Addendum to Planning Statement

Former Electricity Board Site, Bartons Road, Havant

Planning Application Reference APP/25/00639

Report date: December 2025

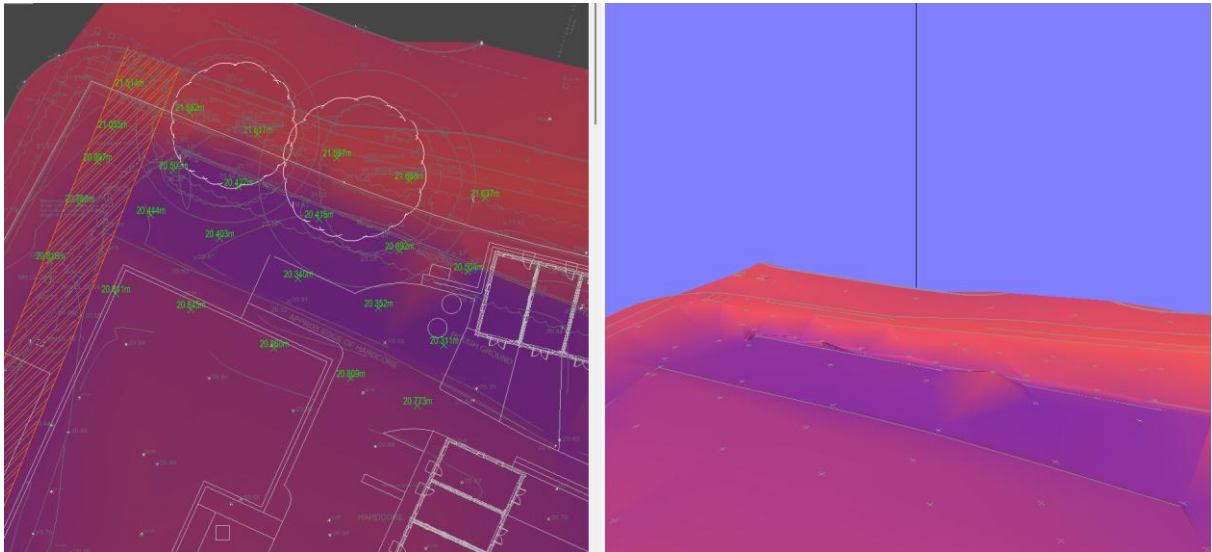
2.1 The key design changes are as follows:

- Additional landscaping along the Petersfield Road frontage to give a verdant character;
- Car parking to meet Havant Borough Council (HBC) standards, which has been rearranged to break up long rows of parking with landscaping;

- Private shared amenity space northwest of the apartment block to supplement balcony provision for the apartments;
- Centralised play space set back from dwellings with good natural surveillance;

- Realignment of the internal road layout to ensure efficiency, permeability and avoid the internal layout being dominated by car parking;
- Pedestrian/cycle link to the south to Martin Road;

- Repositioning of the secondary access to the football club;
- Introduction of a right turn lane at the Bartons Road site access;
- Provision of a 3m shared use path from Petersfield Road to Martin Road to connect the wider secured cycling provision along the Bartons Road corridor;

- Introduction of 3-bed affordable rented dwellings to meet local need;
- Dwellings fronting Bartons Road and Petersfield Road to provide active frontages; and

- Rearrangement of dwellings to provide continuous housing frontages along the northern and western boundaries to act as physical noise barriers.
